SUBJECT: Recall Campaigns No. 92V-071, 92V-072 and  
92V-073

# RECALL CAMPAIGN

**REF. NO. 147  
FUEL INJECTION LINES**

**REF. NO. 148  
UPPER STEERING COLUMN  
LOCKNUT**

**Fig.#1a**

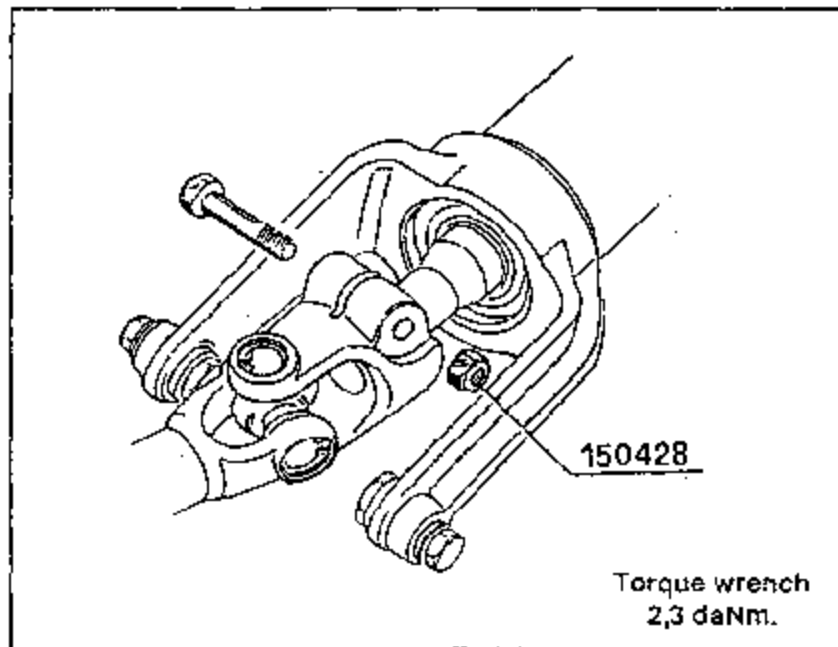
CONDITION: The *upper steering column locknut* may have been manufactured with a lower class of material and self-locking properties. This may result in a loss of tightening torque on the upper steering column fastener. Should such condition remain unnoticed and the use of the car be prolonged for an extensive period of time, loosening of the fastener could occur resulting in play in the steering system and consequential impairment of handling.

REMEDY: Replacement of the Upper steering column locknut with the improved self-locking nut (shown on Fig 1, page 11).

- A. Preliminary: The replacement self-locking nut (Fig.#1a) is supplied as a spare part (PN# 150428) by the Ferrari North America parts department.
- B. Procedure for installation
- 1) Cover interior (seat and carpeting).
  - 2) Remove 13mm locknut from upper steering column fastener and replace with new 13mm self locking nut (PN# 150428) as shown in fig.# 1 below.
  - 3) Check that the steering column shaft is properly inserted into the steering column extension. Fastener must go through the groove provided in the steering column shaft.
  - 4) Torque self-locking nut to 2.3 daNm (17 lbs/ft).
  - 5) Check for binding in steering system. If there is binding, check system for faults.
  - 6) Remove all protective covers from interior and insure that the area is clean.

**Fig.#1b**

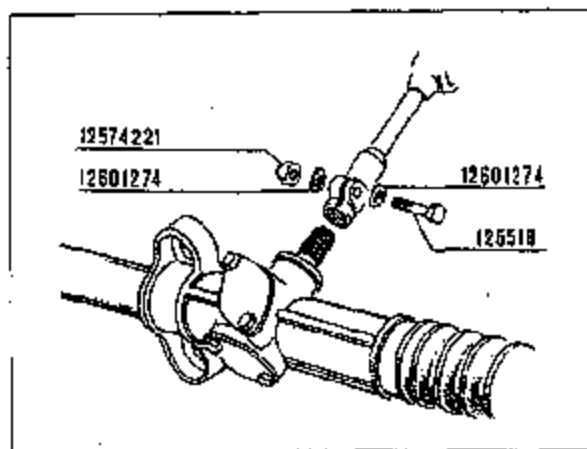
CONDITION: On 348 ts/tb vehicles with Vehicle Identification Number lower than 86212, the *steering box extension fastener* may have been manufactured with a lower class of material and self-locking properties. This may result in a loss of tightening torque on the upper steering column fastener. Should such condition remain unnoticed and the use of the car be prolonged for an extensive period of time, loosening of the fastener could occur resulting in play in the steering system and consequential impairment of handling.

REMEDY: Replacement of the Steering box extension fastener with the improved fastener (shown on Fig 1, page 13).

- 5) Install new fastening bolt along with the two washers and locknut as shown in fig.# 1 below.
  - 6) Torque Fastener nut to 1.2 daNm (9 lbs/ft).
  - 7) Replace carpeting around area of steering extension.

Fig.#1

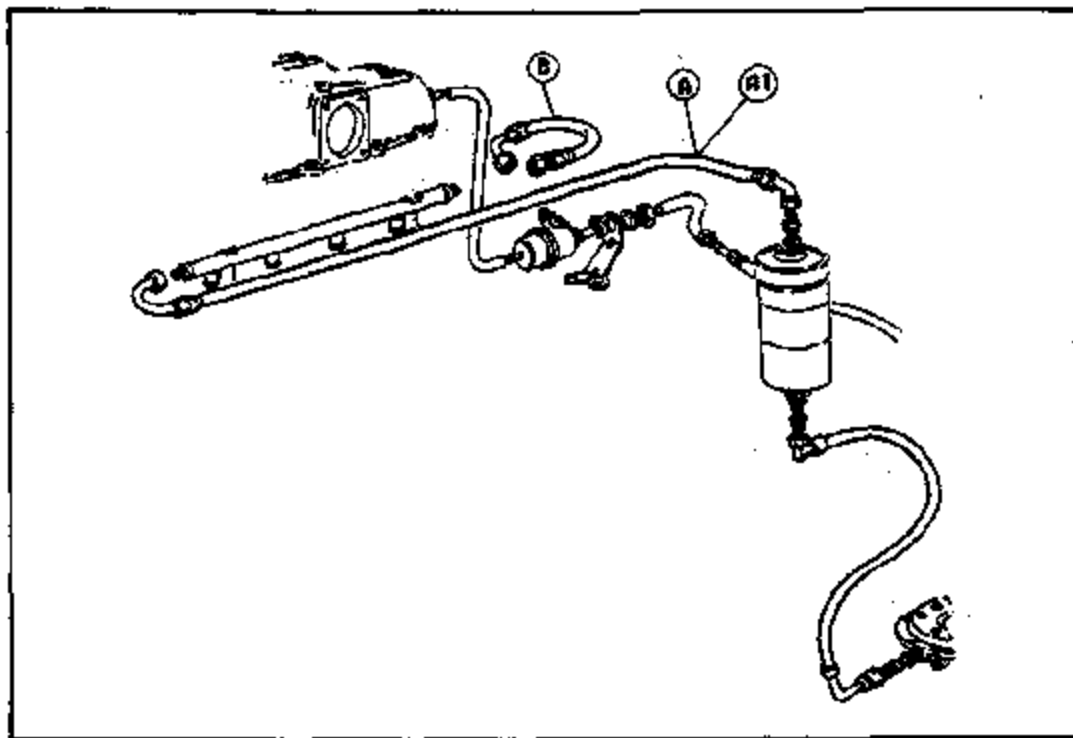
- CONDITION:** The aluminum fuel line fittings on certain fuel Injection lines may corrode under extreme environmental conditions. Should such condition remain unnoticed, the result could be breakage of the aluminum fuel line fitting resulting in fuel leakage.

- REMEDY:** Replacement of the Fuel injection system lines "A & B" with the modified fuel lines (shown on Fig 1, page 6).
- PARTS:** Quantities required for each vehicle and identification of the new Fuel lines with the new part numbers, are shown on the Parts List Table "A" on Page 8). The new part fittings are now aluminum with a non-corrosive coating.

- 5) Remove both fuel lines "A & B" as shown in Fig.# 1 and replace with new lines.
- 6) Inspect 1/4 bank Fuel Injection return line for any damage due to contact with the timing cover. If damage is found the line must be replaced using the procedure "C - Procedure for replacement of fuel return line" found on page # 7 of this booklet. If no damage is found, please insure that the return line is secured on the clip found on the timing cover (Fig.#3). Also the Return Fuel line must not contact the Timing cover or A/C Compressor lines.
